# 802.3dj D2.1

## Comment Resolution

### Electrical Track

Adee Ran (Cisco), 802.3dj Electrical Track Lead Editor  
Matt Brown (Alphawave Semi), 802.3dj Chief Editor  
Howard Heck (TE Connectivity)

Figure 176D–6—Reference insertion loss budget at 53.125 GHz

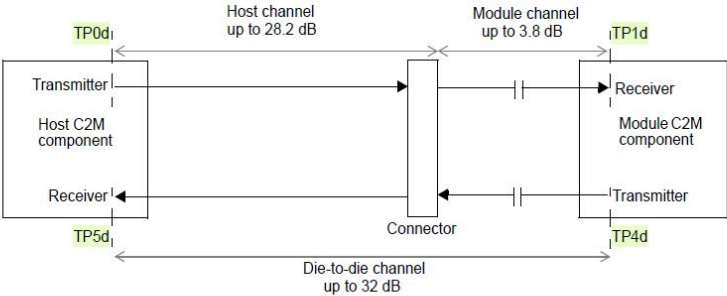
TP0d, TP1d, TP4d, TP5d are undefined in 176D. Also, the COM model includes assumptions above a device (die) and the related package, identifying different loss classes based on the package. Thus there is a conscious recognition of the device and device package in the specifications, though indirect.

Within this figure (or a new complementary figure) provide illustrations of the device, package, and the interfaces between the device and package, etc., as is done in Figure 178-2, Figure 178-3, and Figure 178-5. As a minimum define TPxd.

This subclause describes the expected properties of the channels from TP0d to TP1d and from TP4d to TP5d, as depicted in Figure 176D–6. TP0d and TP5d represent the host C2M component output and input, respectively, at the device-to-package interface, similar to the definitions of these test points in Table 179–6. TP1d and TP4d represent the module C2M component input and output, respectively, at the device-to-package interface. These test points are typically not accessible in an implemented system.¶

Editors' recommendation: ACCEPT IN PRINCIPLE.  
Change the text of 176D.7 as shown on this slide.

Figure 178-6

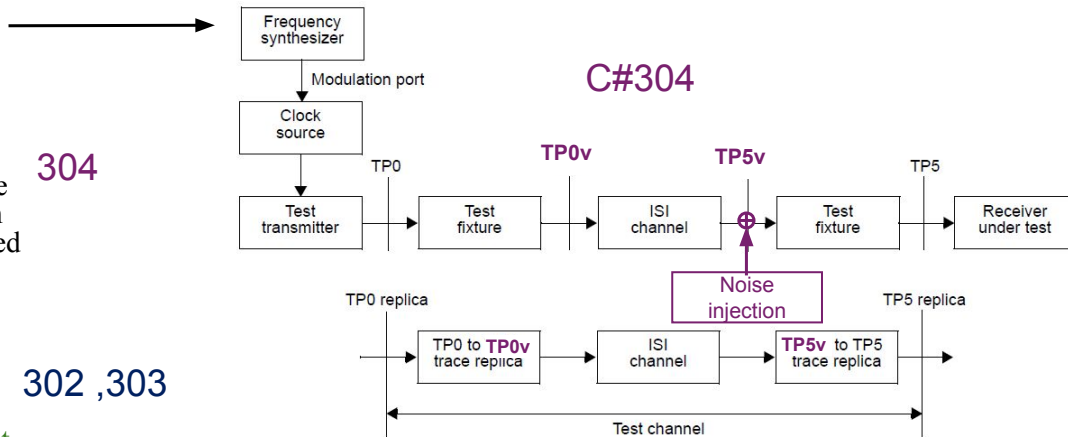
Figure 93-12 does not include broadband noise injection and therefore does not represent the specified jitter tolerance test setup. It is unclear why there are references to Annex 93A, 93C, and 120D.

Add a new figure to 178.9.3.5 that illustrates a test setup with both jitter and noise injection. Replace the second sentence of the first paragraph of 178.9.3.5 with a reference to this new figure.

Editorial team recommendation: ACCEPT IN PRINCIPLE.  
Implement the changes on this slide with editorial license..

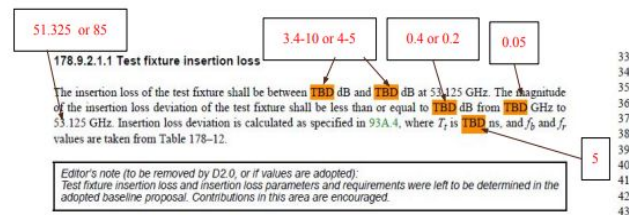
TP0 to TP0v test fixture specifications has multiple TBDs.

As initial values, we can use the values from clause 163 scaled by a factor of 2.

ILd between 3.4 dB and 10 dB at 53.125 GHz.

ILD magnitude up to 0.4 dB from 0.05 GHz to 53.125 GHz.

$T_r$  is 0.005 ns

PROPOSED ACCEPT IN PRINCIPLE

The comment addresses an open TBD and the comment and the suggested remedy are reasonable, but consensus is not obvious.

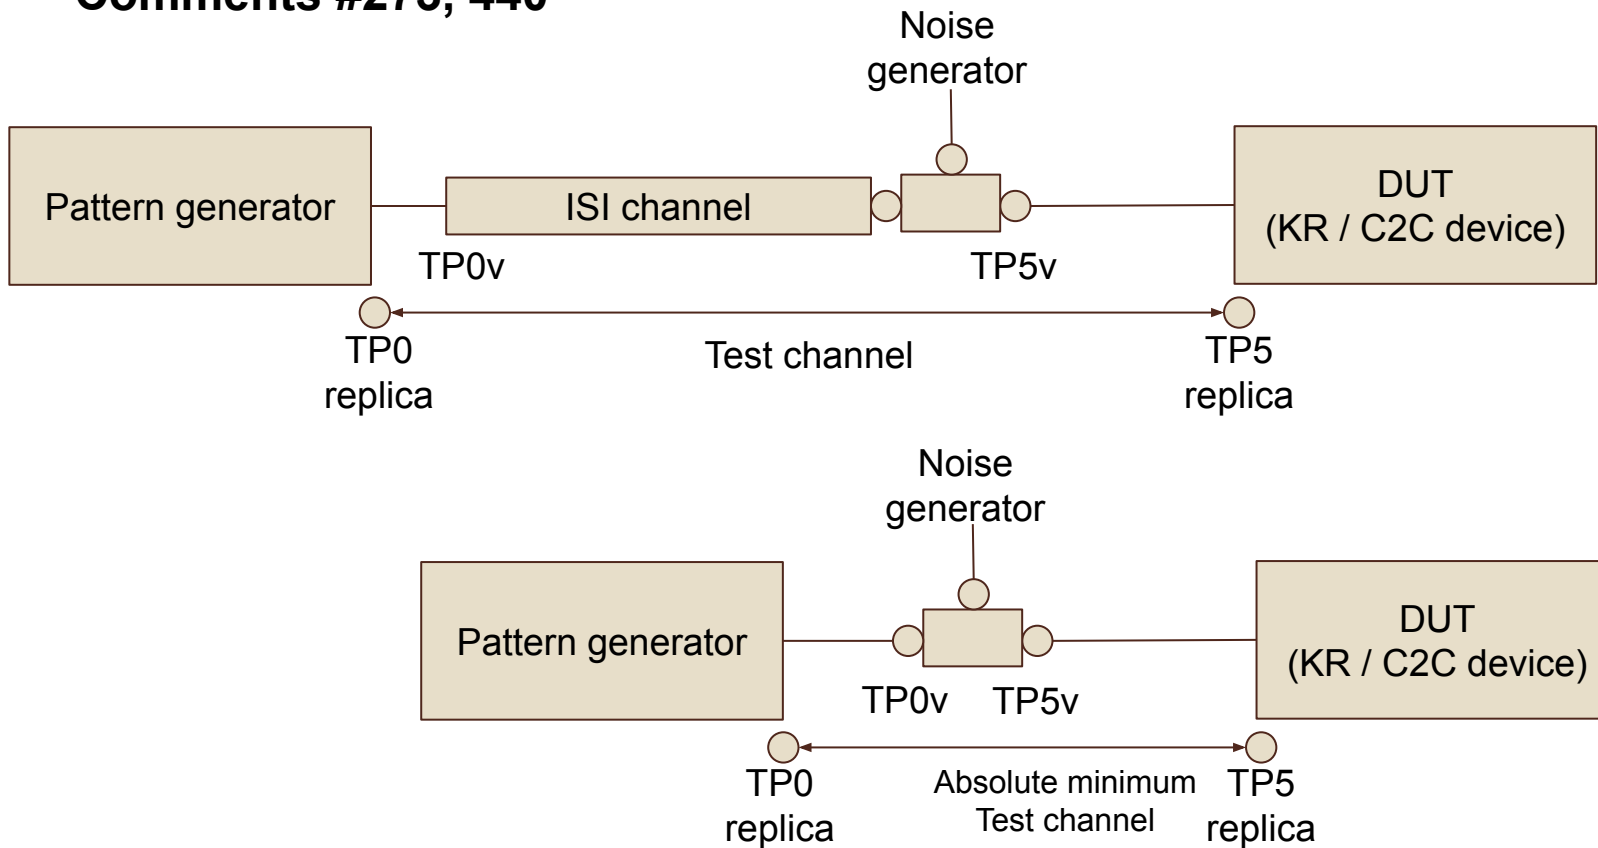
This comment is related to unsatisfied comment #535 to D2.0. Inserting the the minimum channel loss from the KR interference tolerance test (14.5dB) between the Tx and Rx does not adequately test the overload for C2C where much lower minimum losses are expected. (The minimum loss is presently not specified for C2C. Assuming that the pattern generator used in the overload test has a similar loss to a minimum loss real package the loss should be equal to the minimum loss in the C2C link. 2dB allowing for a minimum trace length of approx 2 inches with low loss materials seems reasonable.

Change "using a channel with the minimum insertion loss specified in 178.9.3.4" to "using a channel with the recommended minimum insertion loss specified in 176C.7.2. Add another paragraph to 176C.7.2. "The recommended minimum insertion loss for the channel between TP0 and TP5 is 2dB."

PROPOSED ACCEPT IN PRINCIPLE.

Align the minimum channel loss with that used for RX ITOL testing (9.5 dB - 10.5 dB) by changing the reference in the first paragraph of from 178.9.3.4 to Table 176C-5.
